REMARKS

Dee
00-113-TAP
Reduced Sensitivity Spin Valve Head
for Magnetic Tape Applications
Page 10 of 11

Figure 10A

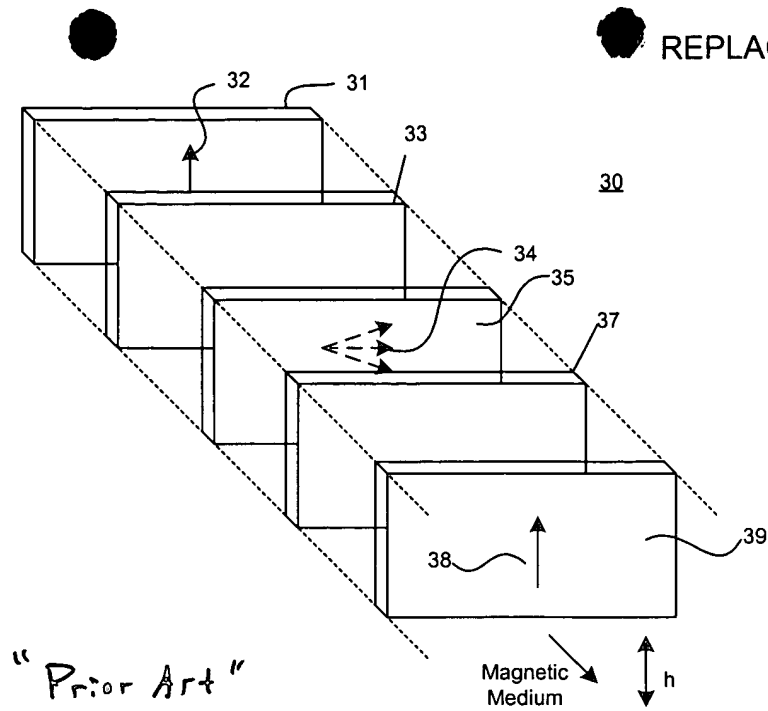
Also, applicants have submitted proposed correction to drawing labeled 10A as suggested by the examiner in red ink. These changes will be incorporated into a formal set of drawings upon approval of the proposed changes by the examiner.

Applicants have submitted proposed corrections to drawings labeled 10A as suggested by the examiner in red ink. These changes will be incorporated into a formal set of drawings upon approval of the proposed changes by the Examiner.
